Model: CH-C2 Pro Finisher SR5070 & SR5080		Date: 9-May-18	No.: RD3CA001
Subject: VIBRATING PLATE:ASS'Y		Prepared by: H.K.	
From: 1st CP Business Department CP Business Center			
Classification:	<input checked="" type="checkbox"/> Troubleshooting <input type="checkbox"/> Mechanical <input type="checkbox"/> Paper path <input type="checkbox"/> Product Safety	<input checked="" type="checkbox"/> Part information <input type="checkbox"/> Electrical <input type="checkbox"/> Transmit/receive <input type="checkbox"/> Other ()	<input type="checkbox"/> Action required <input type="checkbox"/> Service manual revision <input type="checkbox"/> Retrofit information <input type="checkbox"/> Tier 2

Model: CH-C2 Pro Finisher SR5070 & SR5080	Date: 15-Feb-19	No.: RD3CA002a
---	-----------------	----------------

Subject: Photosensor & Guide Plate		Prepared by: H.K.	
From: Sales Strategy Section, 1st CP Business Dep.			
Classification:	<input type="checkbox"/> Troubleshooting <input type="checkbox"/> Mechanical <input type="checkbox"/> Paper path <input type="checkbox"/> Product Safety	<input checked="" type="checkbox"/> Part information <input type="checkbox"/> Electrical <input type="checkbox"/> Tra

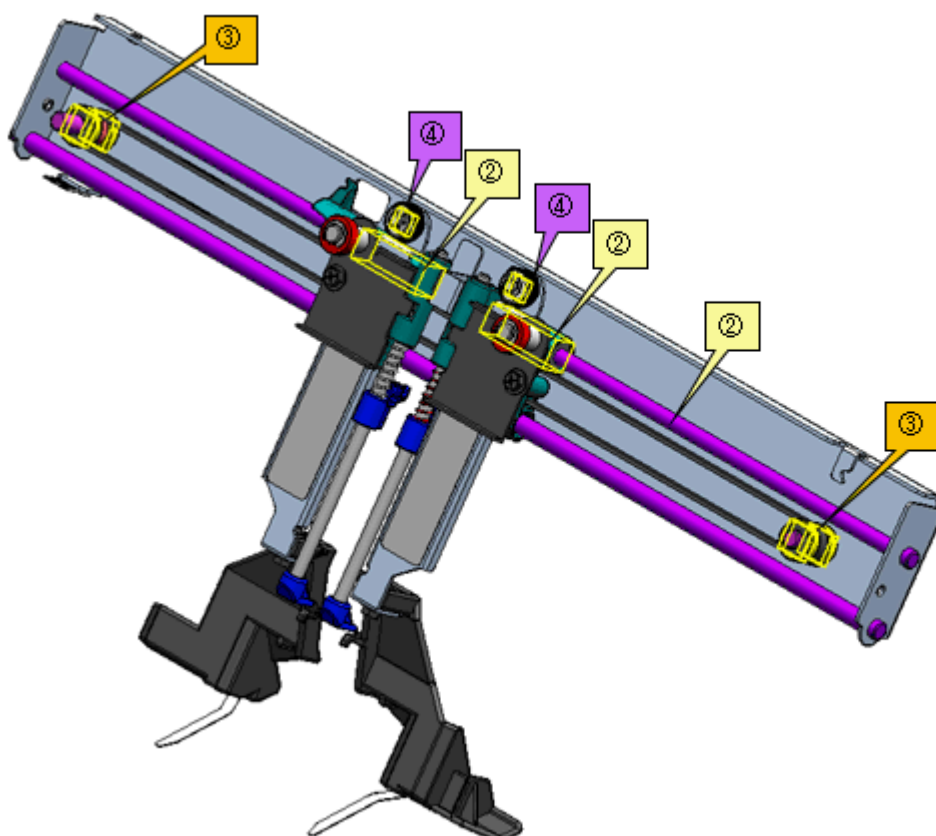
Change: The following changes were made to the vibrating plate assembly of the corner stapling unit:

- ① The bearings on the slider shaft were replaced with bushings.
- ② The bearings in the slide plate were replaced with bushings.
- ③ The pulleys for the belt drive were replaced with ball bearings.
- ④ The vibrating plate rollers were replaced with ball bearings.

Reason: For smooth movement of the vibrating plate, to prevent SC720-35 (Trailing Edge Press Motor Error)

2. Bearing (old) or bushing (new) on the slider shaft

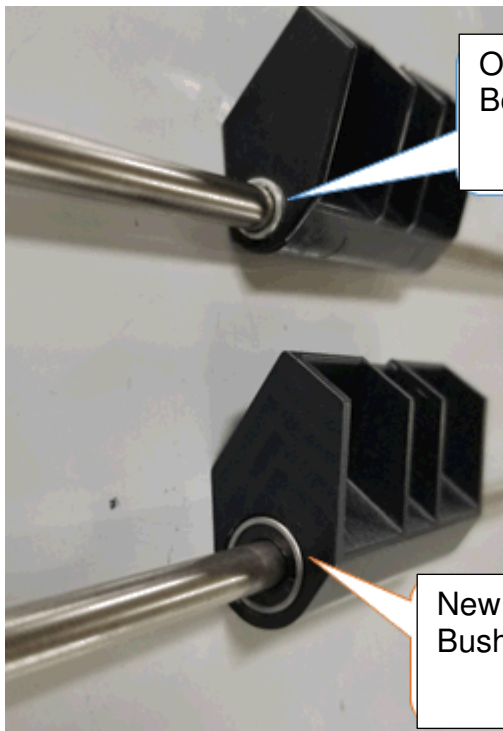
Check if the slider is installed with bearings or bushings.

Check the slider shaft.

Old: The outer race of the bearing touches the shaft.

New: A black bushing touches the shaft.

Important: Cleaning maintenance of the shaft is unnecessary for the new unit.

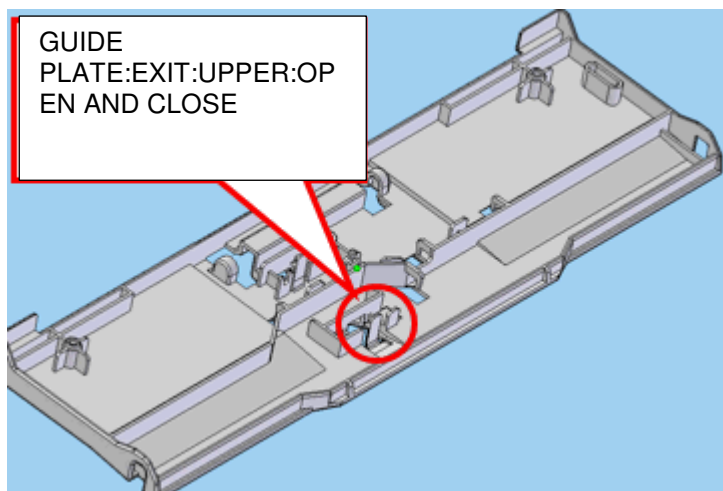
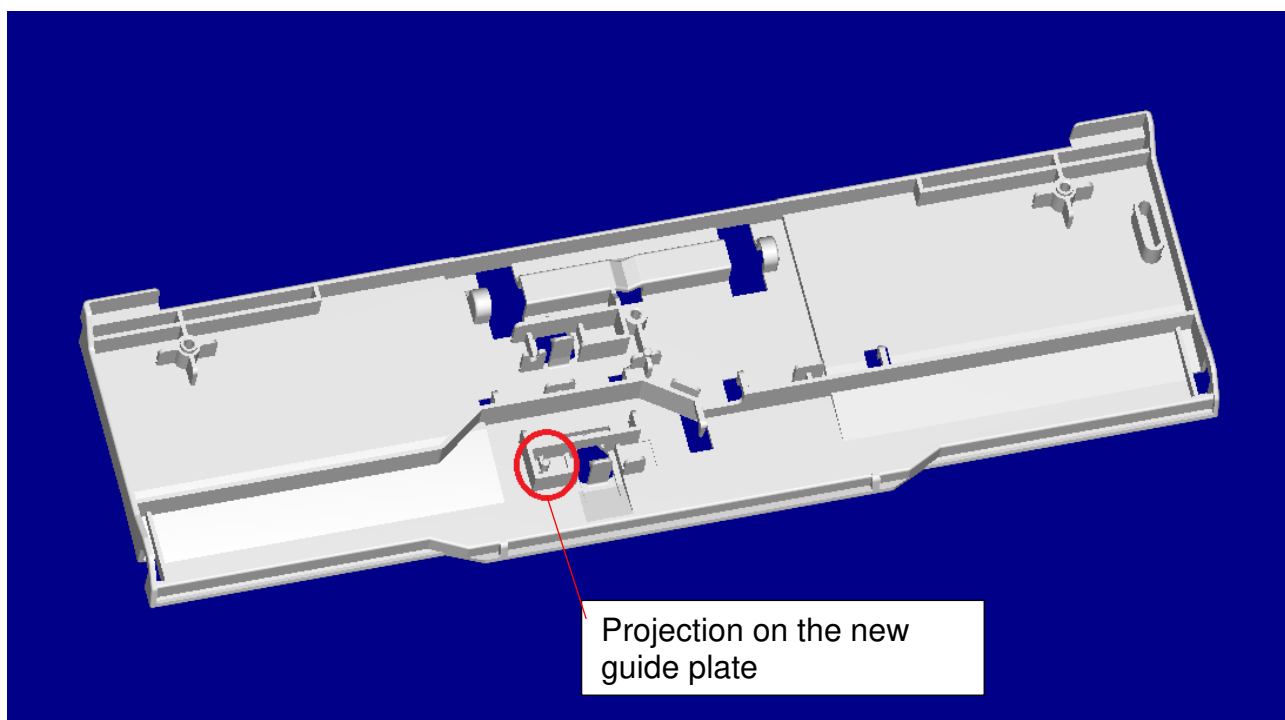
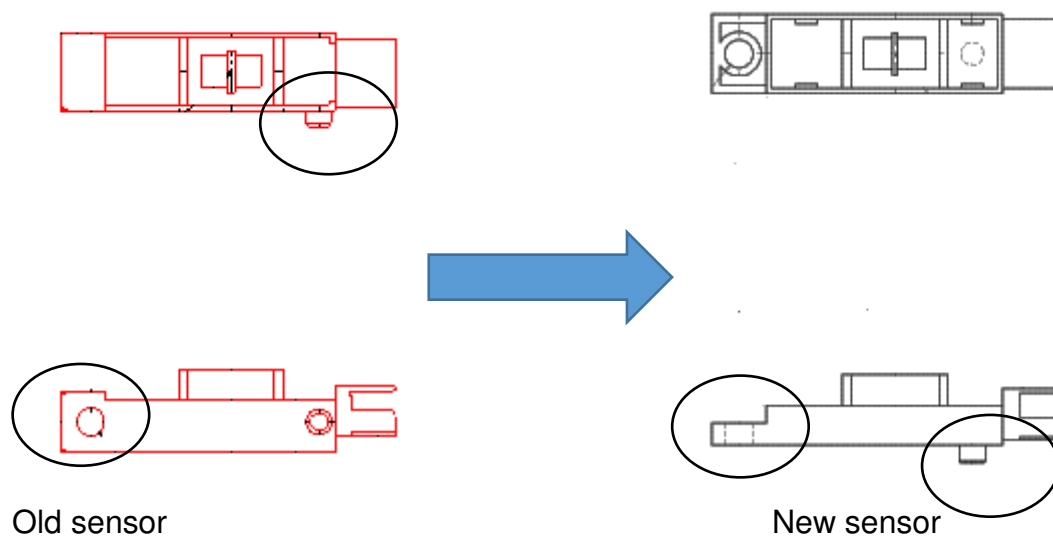
The shape of the GUIDE PLATE:EXIT:UPPER:OPEN AND CLOSE was changed for the new sensor. (A projection was added on the New Guide Plate.)

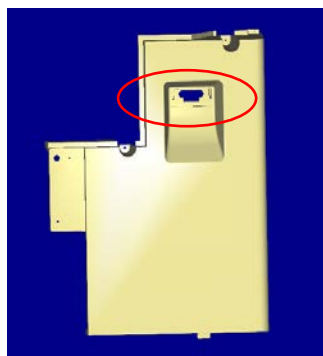
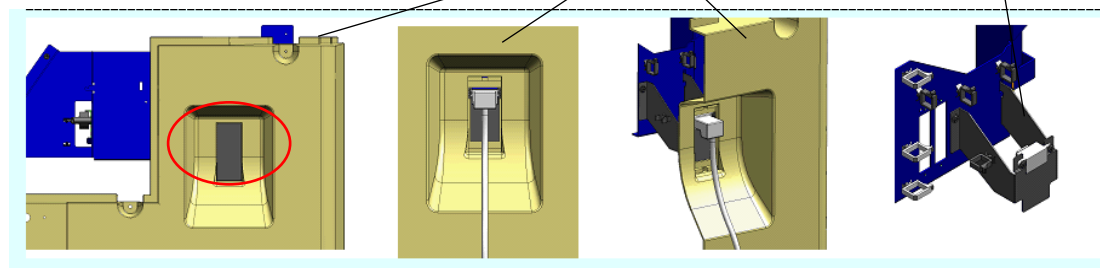
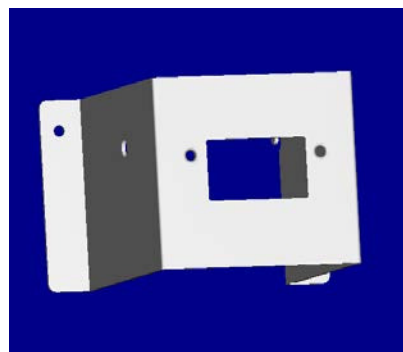
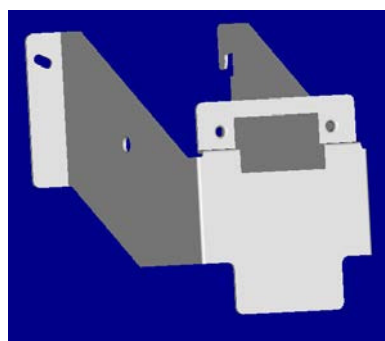
Change: The shape of the Left rear lower cover and Connector bracket changed.

The Bracket is not used for SR5070. Only the Left rear lower cover changed.

COVER:LOWER:PAPER EXIT SUB-UNIT:PAPER CRIMP:PRESS

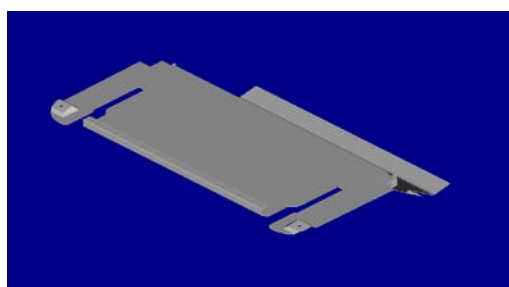
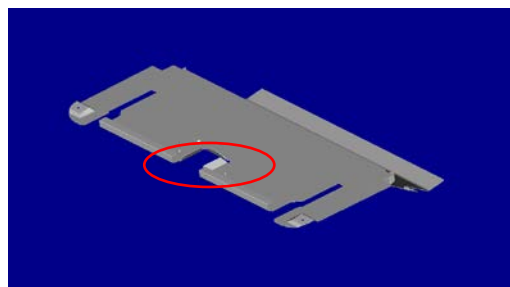
Change: The cutout on the Lower Cover of the paper exit sub unit was covered with a Tray Cover using two screws. (The cutout was purposed for parts standardization with other models.) The Label attached to the transport unit lower cover was eliminated.

GUIDE PLATE:LENGTHWISE UPPER:OPEN AND CLOSE

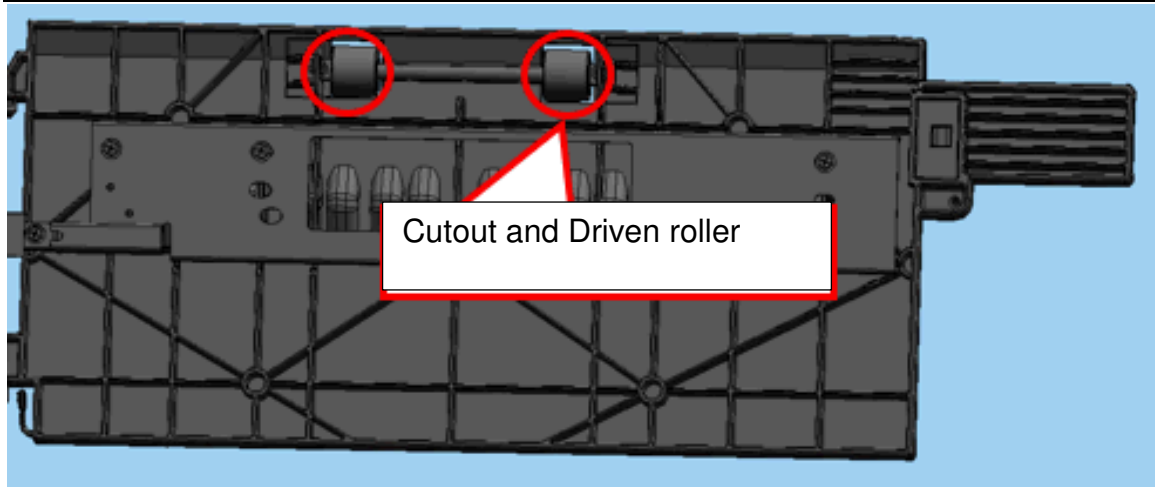
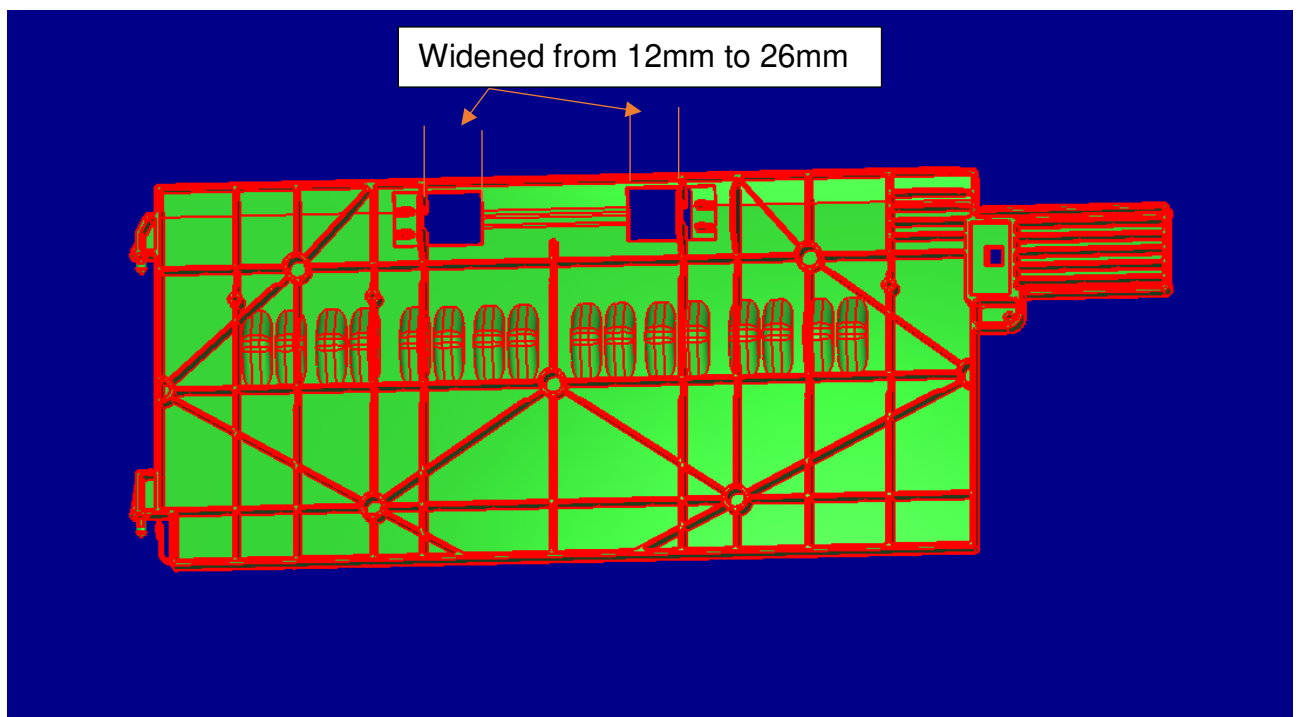
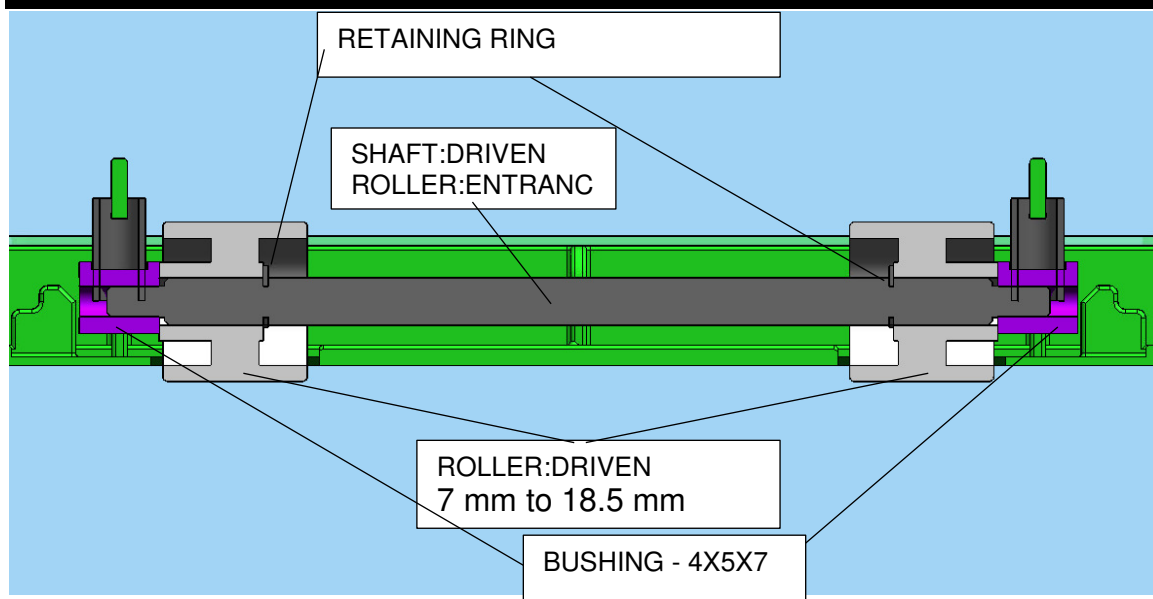
The cutouts on the Open and Close Upper Lengthwise Guide Plate for the driven rollers were widened from 12mm to 26mm. The width of the driven roller was changed from 7 mm to 18.5 mm. The driven roller can be procured separately.

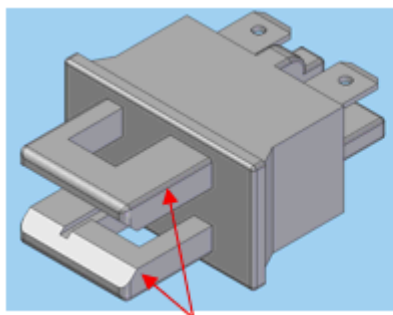
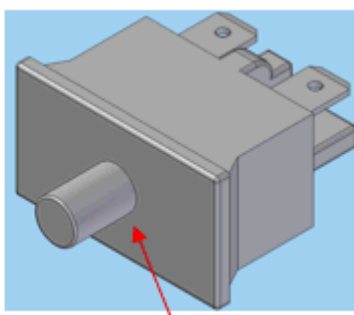
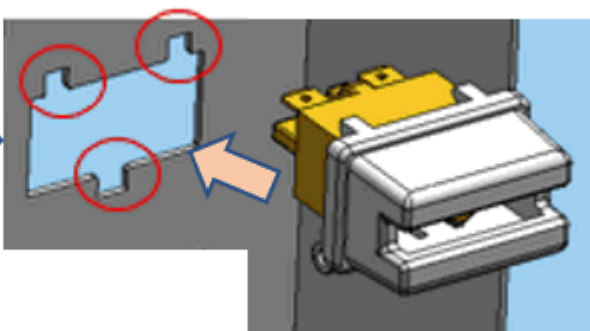
The material and shape of the Push Switch were changed. The shape of the Hook Safety Switch Cover was changed for the new sensor. The cutout of the side plate of the Finisher was changed for the new Push Switch and Hook Safety Switch Cover.

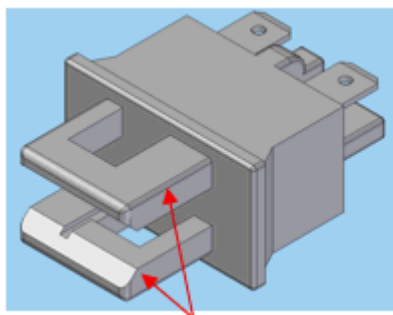
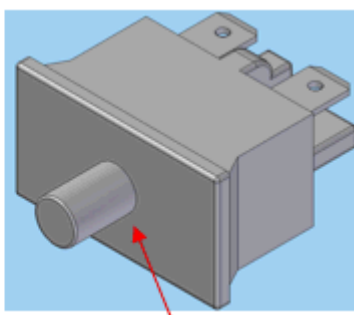
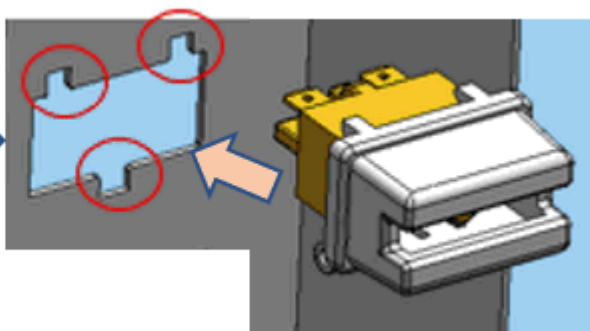
The material and shape of the Push Switch were changed. The shape of the Hook Safety Switch Cover was changed for the new sensor. The cutout of the side plate of the Finisher was changed for the new Push Switch and Hook Safety Switch Cover.

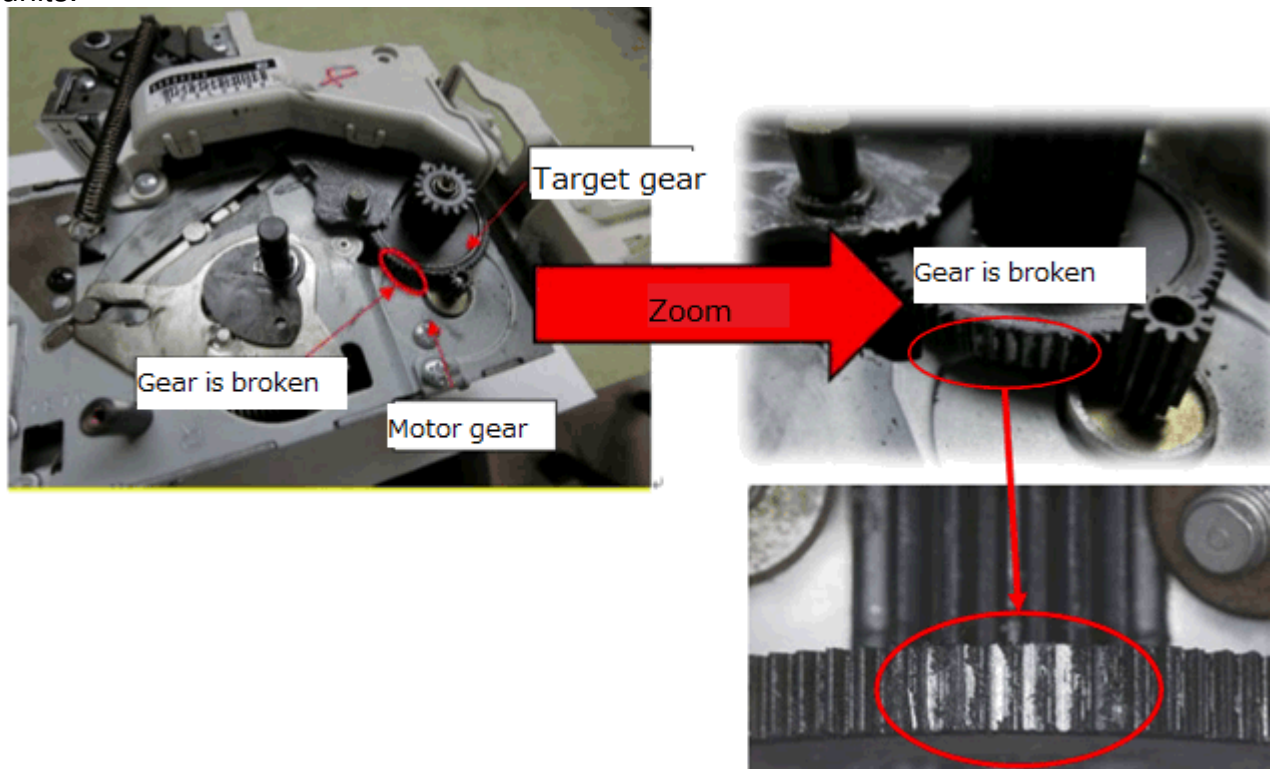
SC720-44 may occur after around 100,000 times staples.

The gear on staple unit gets damage since defective gear is contained in some of staple units.

Check the serial number of the Staple unit, and if the number is target, then replace the unit to the following part number.
